**Subject:** Juanita Lateral Migration Timeline and Snips

- July 8, 2024 – Preliminary Juanita Creek Hydraulic Design Report submitted.
- January 28, 2025 – Final Juanita Creek Hydraulic Design Report submitted.

ELEVATION - EAST PORTAL

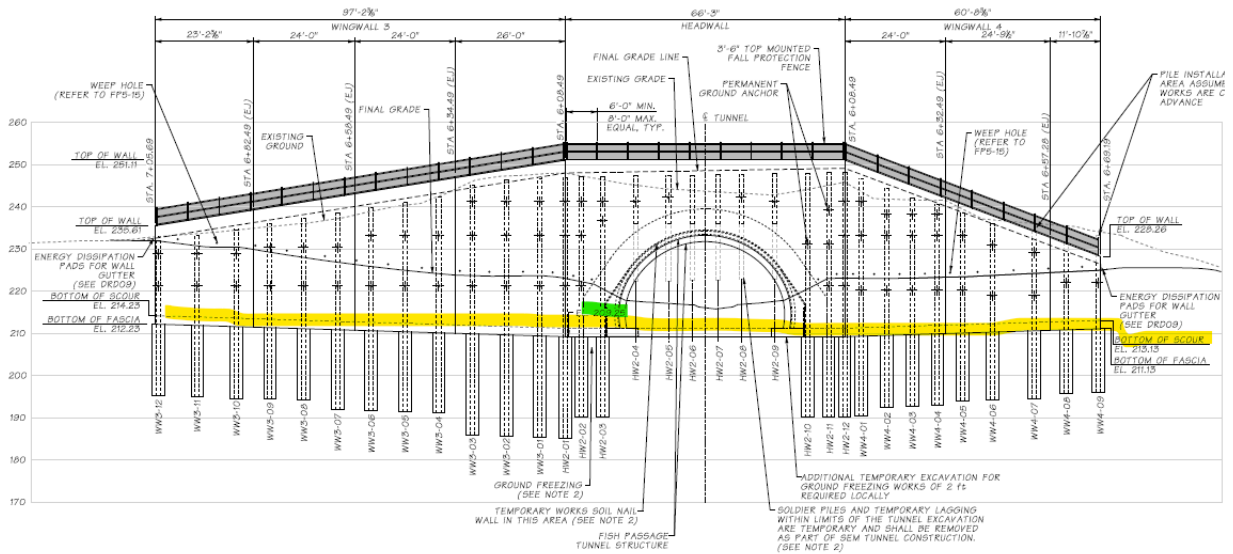
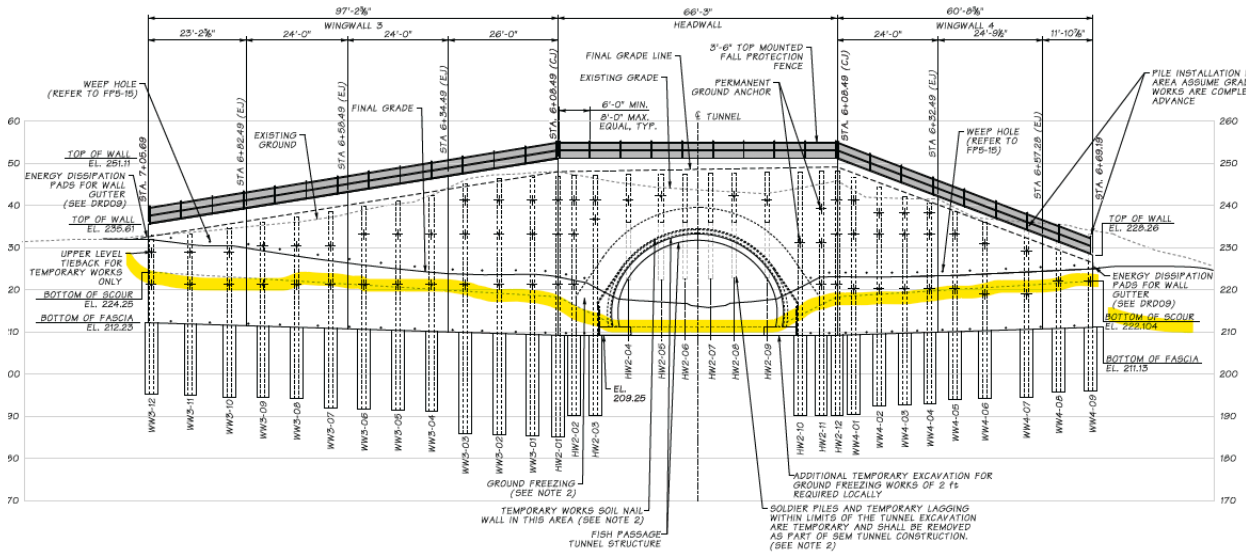
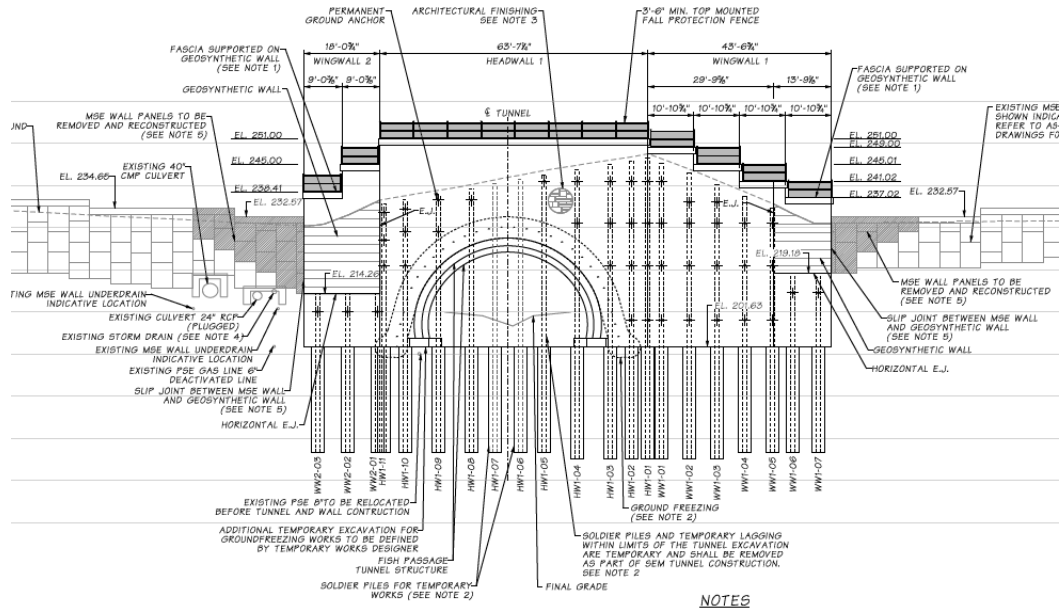
- September 16, 2025 – Final Juanita Creek East Portal submittal included updated pile depths. The submittal occurred after the Fish Passage Task Force meeting and WSDOT comment closure on lateral migration on July 28, 2025.

- September 17, 2025 - Preliminary Juanita Creek West Portal design submitted.
- December 31, 2025 – RFC Juanita Creek East Portal submittal contained no changes relative to the final design regarding pile depth.

- July 28, 2025 – WSDOT Comments on lateral migration were closed consistent with Contract terms: lateral migration at Juanita Creek is defined as low and shall be followed, otherwise need a DBIC from Design Builder.

ELEVATION - WEST PORTAL

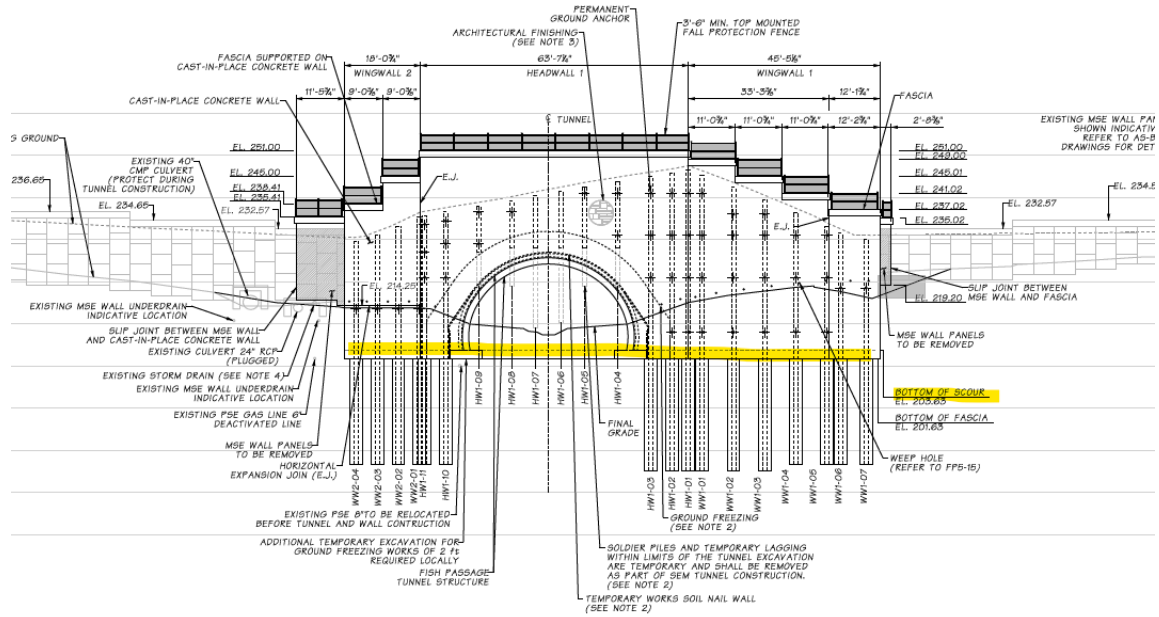
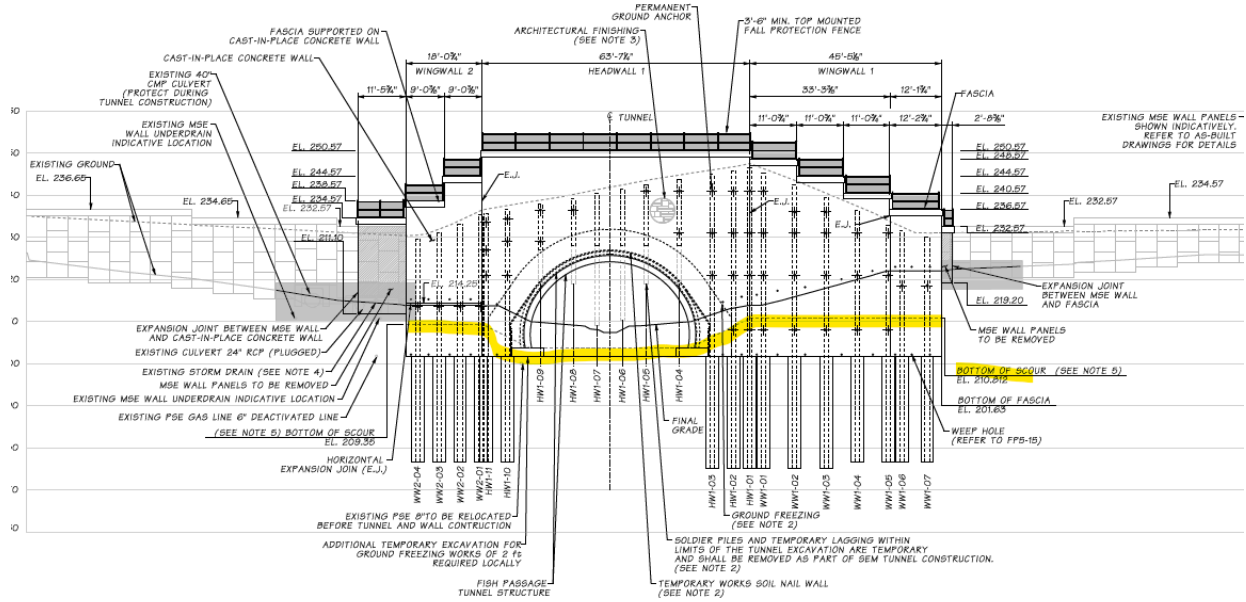
- February 23, 2026 - RFC Juanita Creek West Portal
